# LEGACY CAPITOL HILL

1525 11TH AVE

RECOMMENDATION MEETING  
1/25/2017  
MUP #3023226

EDG PLAN, WITH SOME WINDOWS ON THE MONIQUE LOFTS BLOCKED

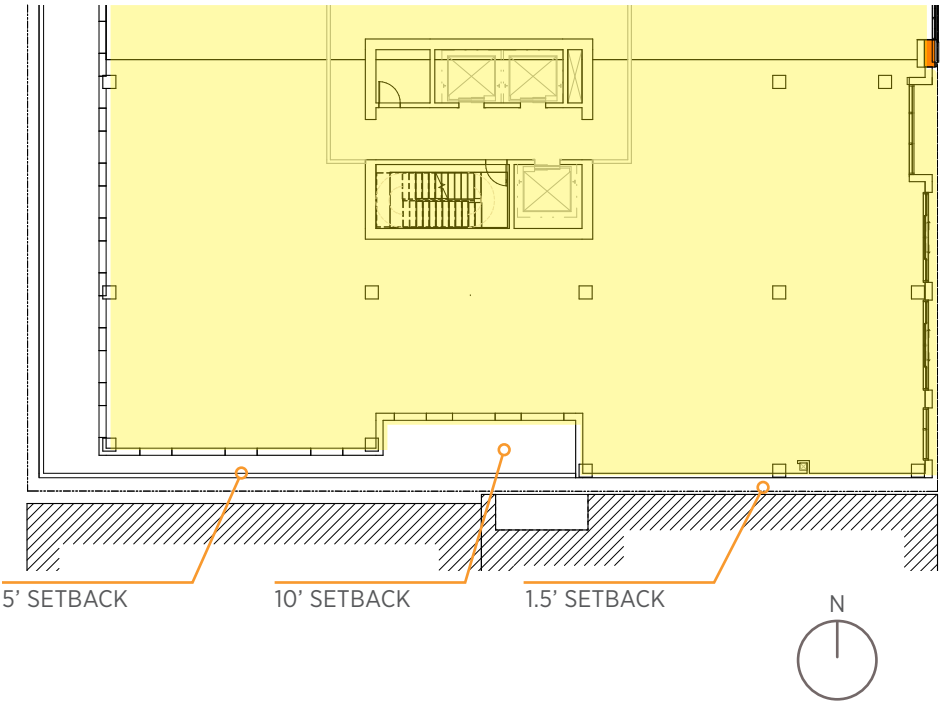
GUIDANCE	RESPONSE	DESIGN GUIDELINES
<p>6 The relationship to the buildings along the rear west property line is acceptable.</p> <p>7 Make every effort to respect the existing windows on the residential structure to the south.</p> <p>8 Given the open floor plan and office use, consider pulling the building back to provide more space for the windows near the property line.</p>	<p>6 The relationship of the new building to adjacent structures along the rear west property lines remains consistent with the EDG presentation.</p> <p>7 Floor plates have been revised to provide a 5' setback from the property line at the locations of windows on adjacent buildings. Windows on the new building have been offset from windows in the Monique Lofts in order to minimize views directly into residential units.</p> <p>8 Windows in the Monique Lofts' light well will be at least 10' from the new building. The smaller windows on the property line will be 5' from the new building. Note that a 5' setback from the property line is consistent with the decisions made by the Monique Lofts developers when the condominium conversion was completed (The light well steps back 5').</p>	<p>6 <u>CS2.D.5</u> <u>Respect for Adjacent Sites</u> Buildings to the west are set back substantially from the proposed project. The new building will set back 10' from the property line along the west.</p> <p>7 <u>CS2.D.5</u> <u>Respect for Adjacent Sites</u> The south elevation of the building has been redesigned in order to preserve light and air as well as provide privacy to users of both structures adjoining the project to the south. Much of the building is set back from 11th Ave on upper levels, enhancing privacy for residents of Sunset Electric.</p> <p>8 <u>DC2.A.1</u> <u>Site Characteristics and Uses</u> The building massing is designed to relate to the scale of the character structure and surrounding buildings, while giving the character structure sufficient space to maintain its integrity. The massing is also configured to allow usable office floorplates.</p>

6 The relationship of the new building to adjacent structures along the rear west property lines remains consistent with the EDG presentation.

**SECTION 1**  
PROPOSED BLDG @ 1016 PIKE

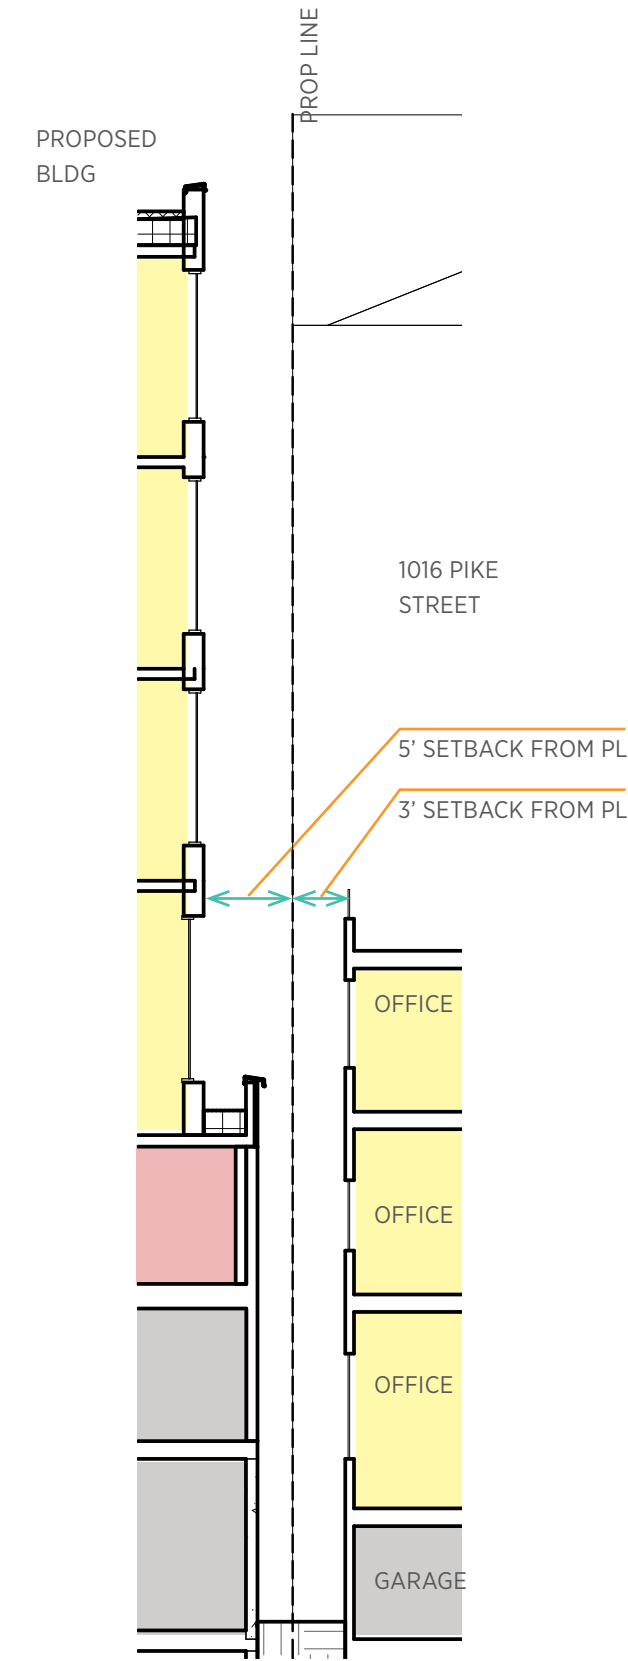
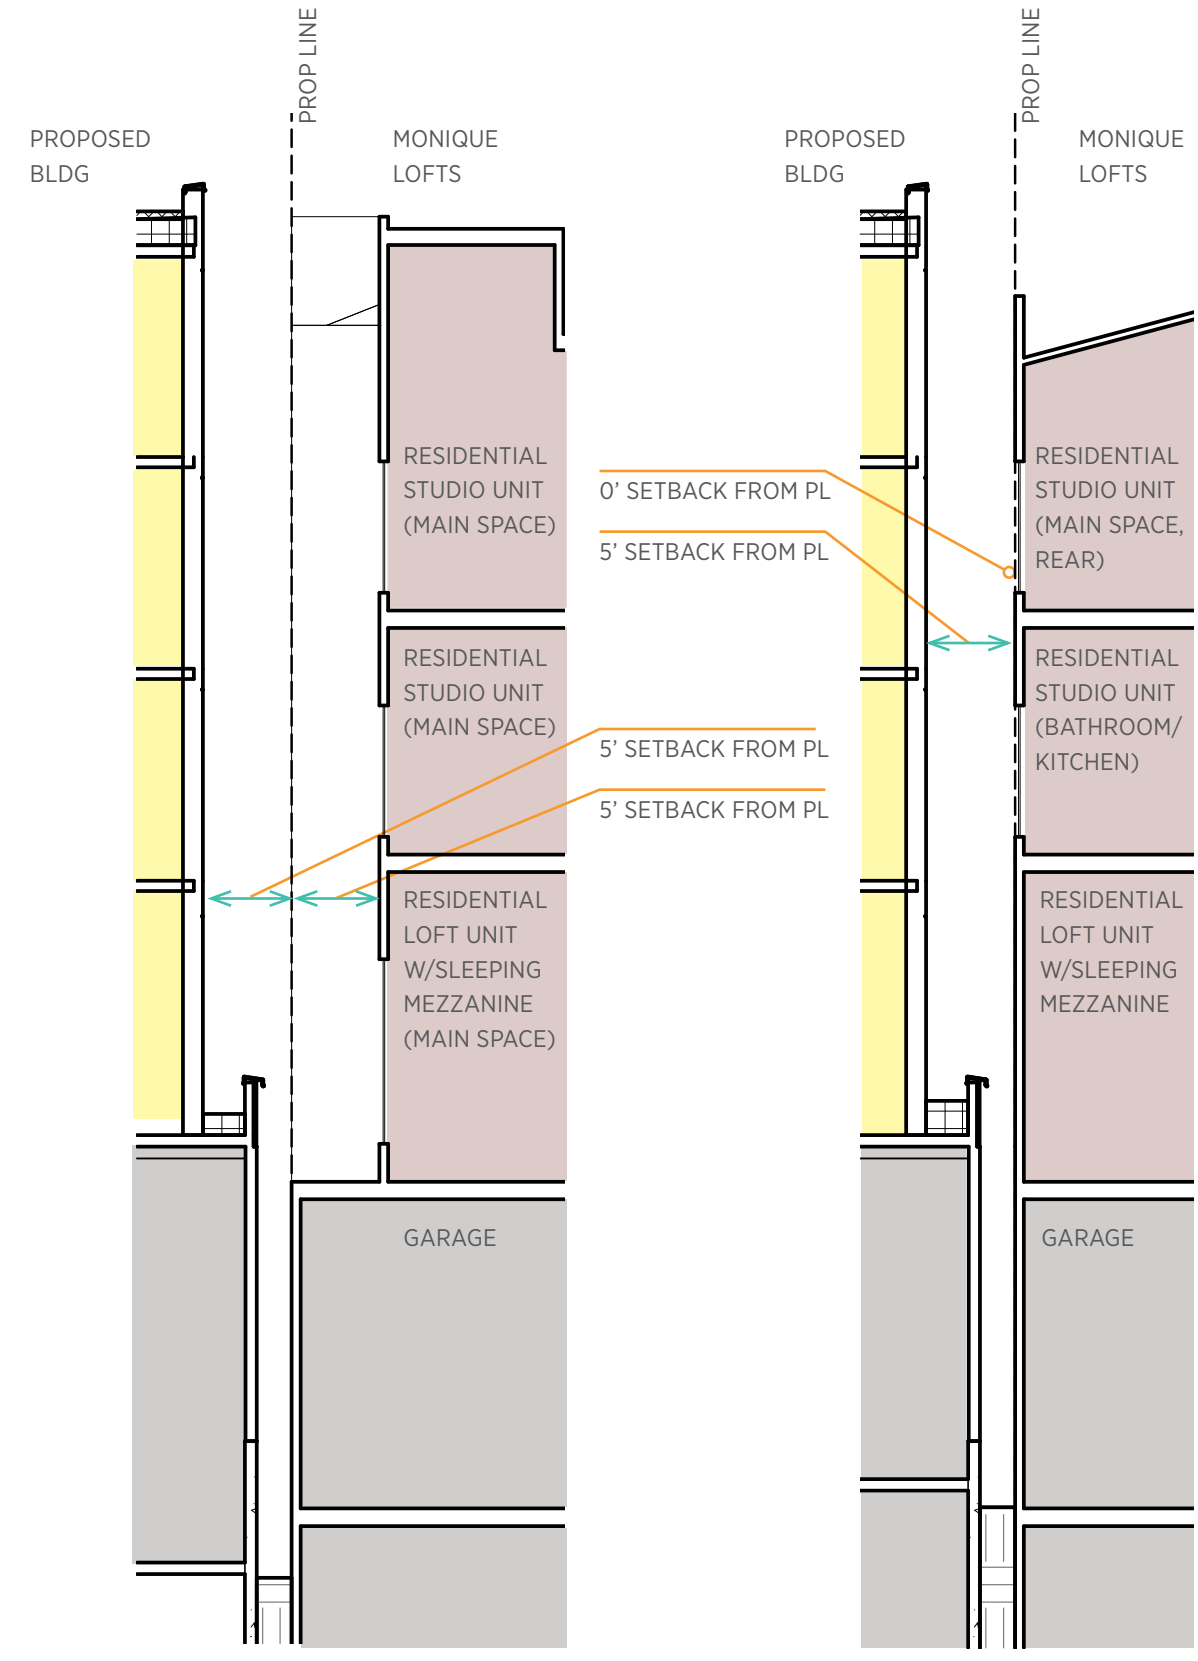
8 Windows in the Monique Lofts' light well will be at least 10' from the new building. The smaller windows on the property line will be 5' from the new building. Note that a 5' setback from the property line is consistent with the decisions made by the Monique Lofts developers when the condominium conversion was completed (The light well steps back 5')

8 Windows on the new building have been offset from windows in the Monique Lofts in order to minimize views directly into residential units.

PARKING/LOADING DESIGN AT RECOMMENDATION

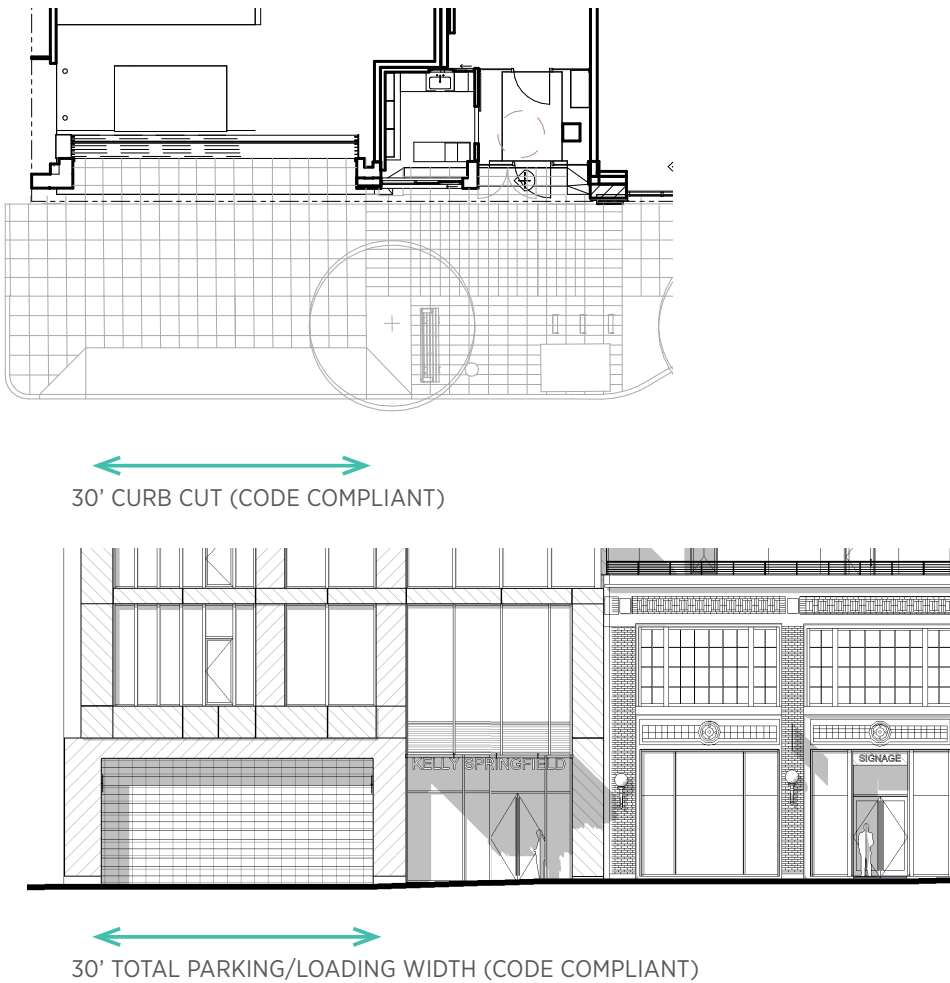
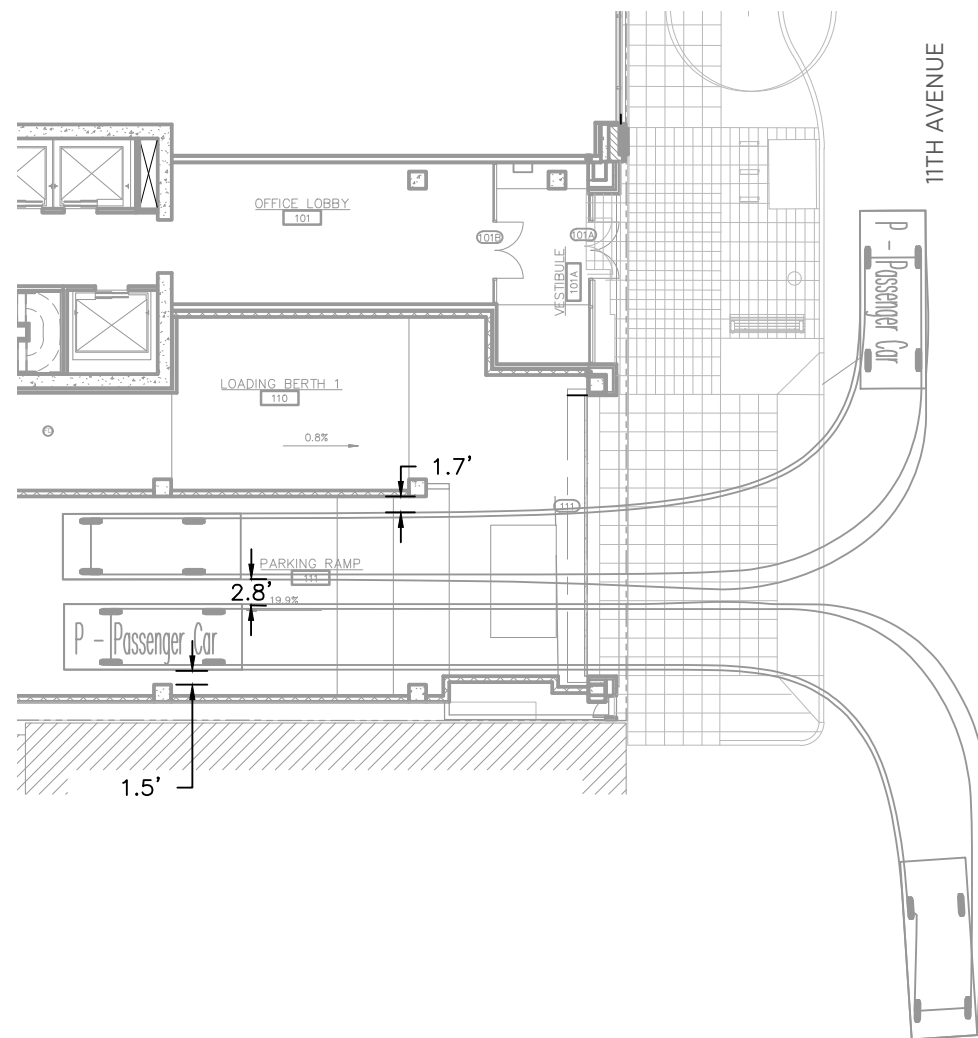
- 13 Minimize the size of the garage doors; consider a smaller loading or smaller garage opening.
- 14 Design the bike access circulation to be more user friendly.

- 13 The departure to allow two garage doors presented at EDG has been eliminated. Parking and loading have been combined into one garage door, with a smaller total width than was presented at EDG. The parking/loading entry door has been minimized to the narrowest dimension possible while still providing safe access for parking and loading.
- 14 The bicycle circulation is user friendly. Two separate methods of access are provided—through the lobby via freight elevator and via the parking ramp. Showers, lockers, and bike ramps are located below grade to centralize bike functions in the building. For public bike usage, bike racks are located on the street.

- 13** The parking/loading entry door has been minimized to the narrowest dimension possible while still providing safe access for parking and loading.
